Access Compliance Report

Public Rights-of-Way

(Curb Ramps)

Intersection ID: 2964	Main Street: COTTAGE_OAKS_DR	Cross Street: WAVERLY_LYNN_LN	Location: SW
ADA ID: 2FEF616207E1	Ramp Type: PerpDiag	Initial Pass/Fail: Fail	Overall Compliance: No
Severity Score: 17.5			
Codes/Mitigation Info/Possible Solution		Field Measurements/Component Compliance

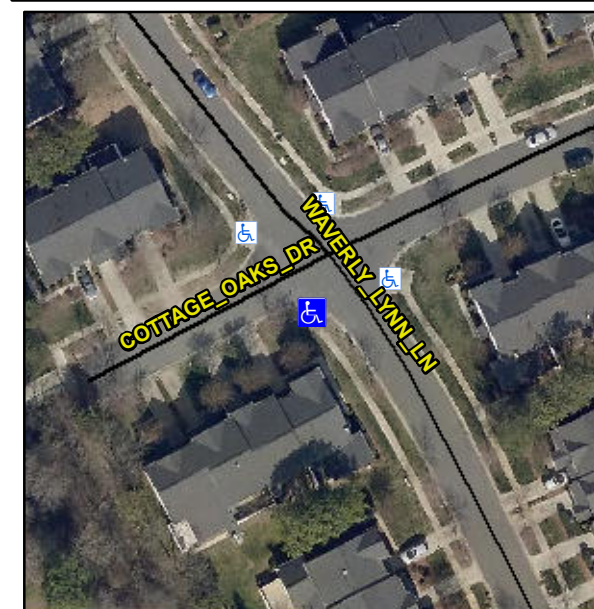
Not Found, R304.5.1

Compliance	Description	Data	Compliance	Description	Data
N/A	Ramp Length (in)	80.0	Yes	Ramp Slope (%)	5.9
No	Ramp Width (in)	34.0	Yes	Ramp XSlope (%)	0.3
N/A	Flare Type LT	N/A	N/A	Flare Type RT	N/A
N/A	Flare Slope LT (%)	N/A	N/A	Flare Slope RT (%)	N/A
N/A	Flare Traversable LT?	N/A	N/A	Flare Traversable RT?	N/A
N/A	Landing Length (in)	N/A	N/A	DWS Provided?	N/A
N/A	Landing Width (in)	N/A	N/A	DWS Contrast?	N/A
N/A	Landing Slope (%)	N/A	N/A	DWS Length (in)	N/A
N/A	Landing X Slope (%)	N/A	N/A	DWS Full Width?	N/A
N/A	Landing Curb? (Y/N)	N/A	N/A	DWS Offset (in)	N/A
N/A	Shared Landing?	N/A			
N/A	Gutter Ponding?	N/A	N/A	Gutter Slope (%)	N/A
N/A	Gutter Lip Ht (in)	N/A	N/A	Gutter X Slope (%)	N/A
N/A	Painted X Walk1?	No	N/A	Painted X Walk2?	No
	X Walk 1 Direction	To N		X Walk 2 Direction	To E
N/A	X Walk 1 Width (in)	N/A	N/A	X Walk 2 Width (in)	N/A
	X Walk 1 Slope (%)	2.5		X Walk 2 Slope (%)	8.0
	X Walk 1 X Slope (%)	3.0		X Walk 2 X Slope (%)	1.1

Remove & Replace Curb Ramp With Two New Directional Ramps or Equivalent.
